Proposal #11: 2265-10-71, WISC 2024116
Oak Creek - Milwaukee
8 Mile Rd to Elm Rd
STH 241
Milwaukee County

This is Addendum No. 01, which provides for the following:

ADDENDUM NO. 01

Addendum No. 01
ID 2265-10-71
Revised Sheet 26
January 3, 2024

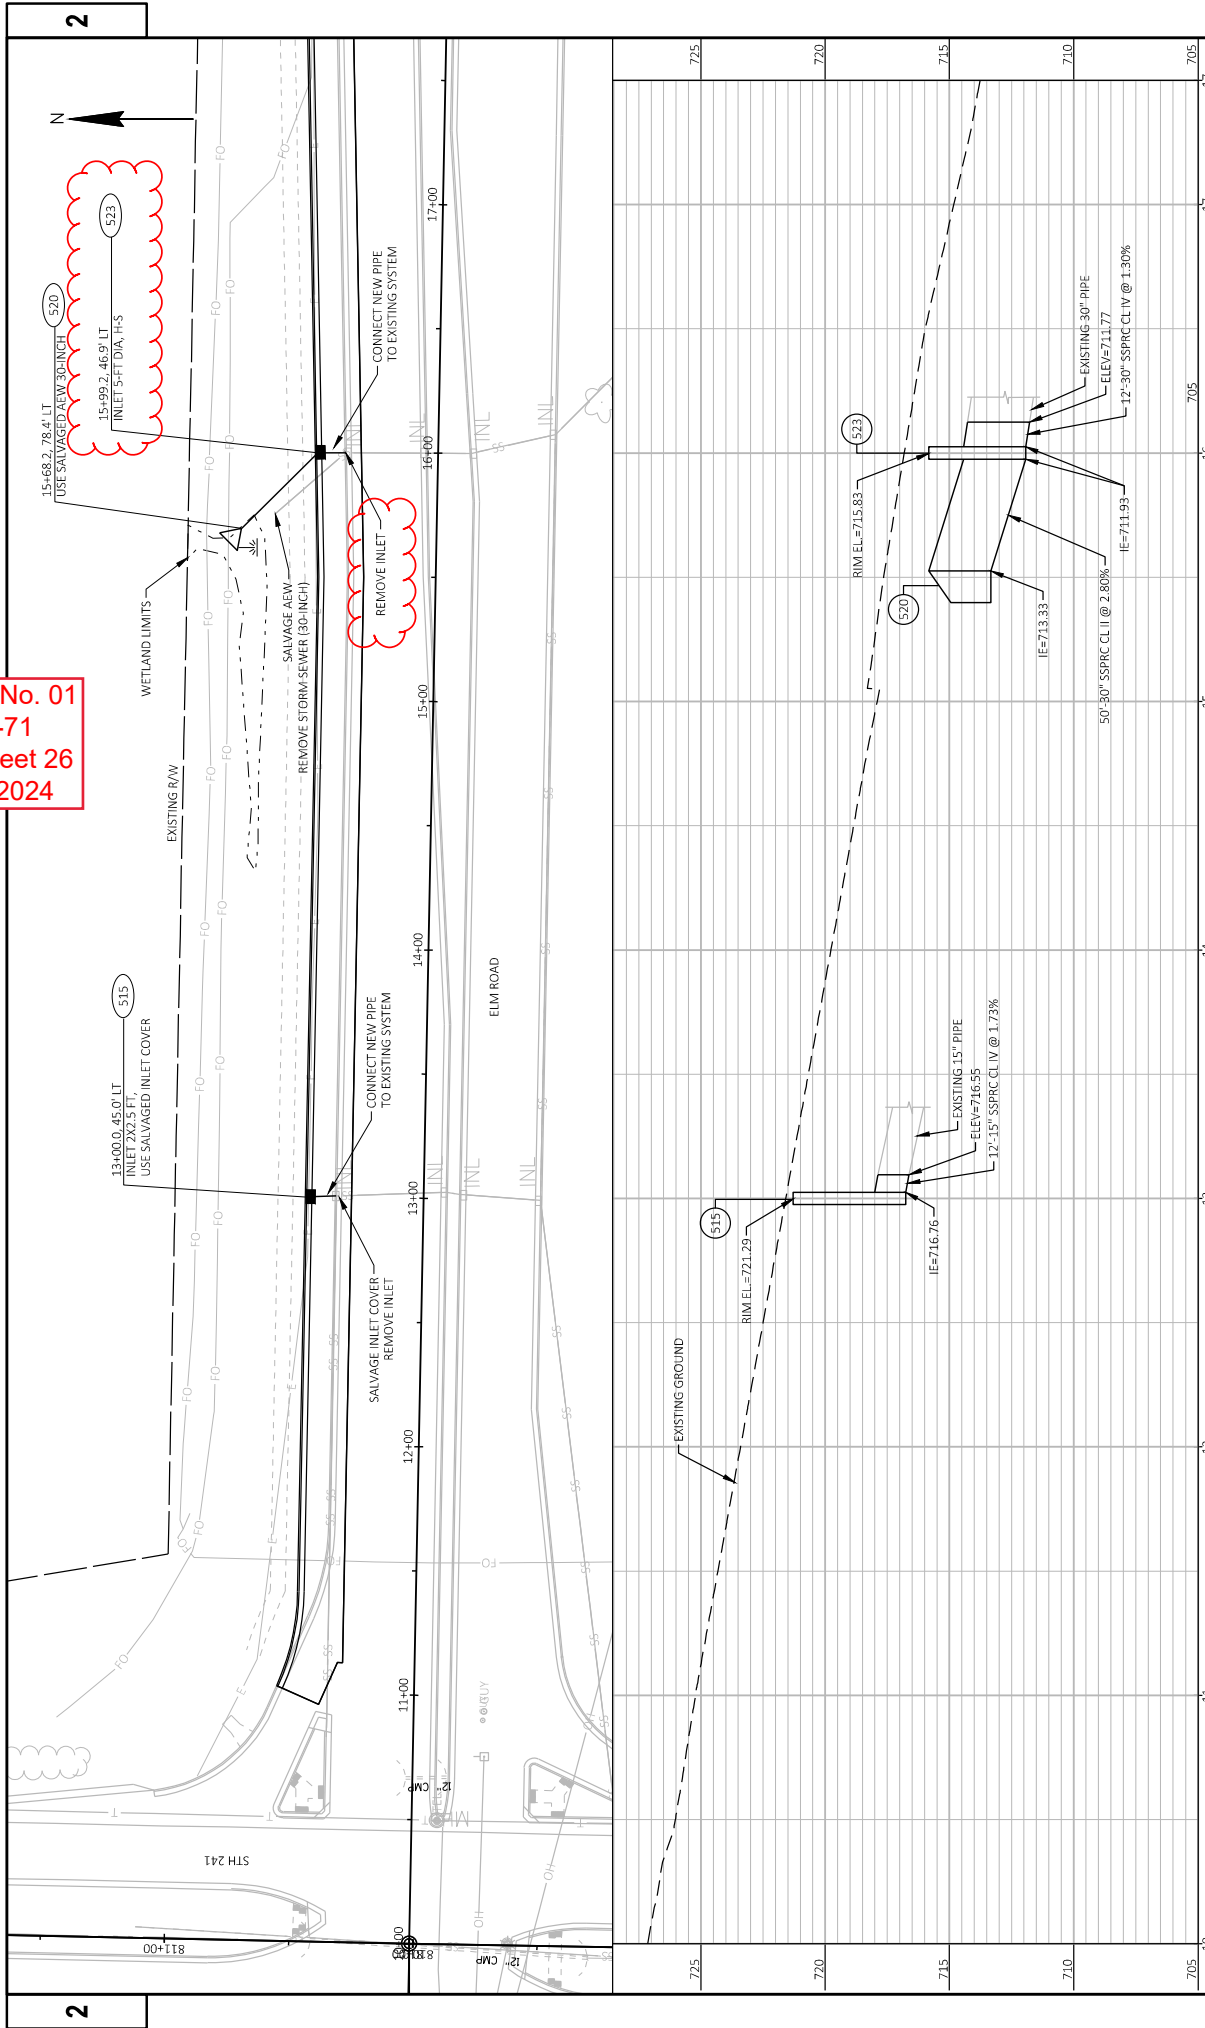
Revised Plan Sheets	
Plan Sheet	Plan Sheet Title (brief description of changes to sheet)
26	Storm Sewer: Elm Rd (revised SS structure type and cover)
64	Miscellaneous Quantities (revised and added quantities for SS structure type and cover)
